February 2013
FL631AB
NHTSA #12V-405
Transport Canada #12-281
REVISED NOTICE

Subject: Perpendicular Aluminum Air Tank Mounting Brackets

Models Affected: Specific Freightliner 114SD, Business Class M2, Cascadia, and Coronado vehicles; Sterling 9500 vehicles; and Western Star 4700 vehicles manufactured July 29, 2008, through December 15, 2011.

Fig. 1, Perpendicular Air Tank Installation

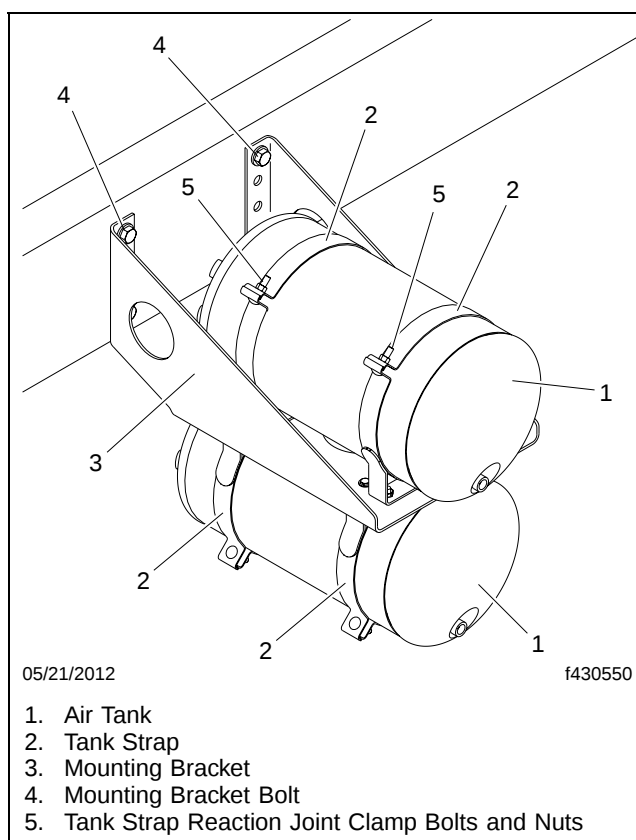
The final remedy is to replace the original aluminum mounting bracket (or steel bracket if interim repair was performed) with a more robust steel bracket. **(Vehicles that had the interim repair performed also require the final remedy.)**

Refer to **Fig. 1** for this procedure.

- 7.4 Raise the corner of the battery box to access the bracket fasteners.
8. Remove the aluminum air-tank mounting bracket from the frame rail.
9. Install the new steel air-tank mounting bracket on the frame rail. Tighten the mounting bolts and nuts 120 to 150 lbf-ft (163 to 203 N·m).

10. Lower the battery box, and install the fasteners. Tighten 120 to 150 lbf-ft (163 to 203 N·m).
11. Install the batteries and the battery box cover.
12. Remove the air tank cradles from the aluminum air tank mounting bracket and install them on the new steel bracket. Tighten the mounting bolts and nuts 25 to 31 lbf-ft (34 to 42 N·m).
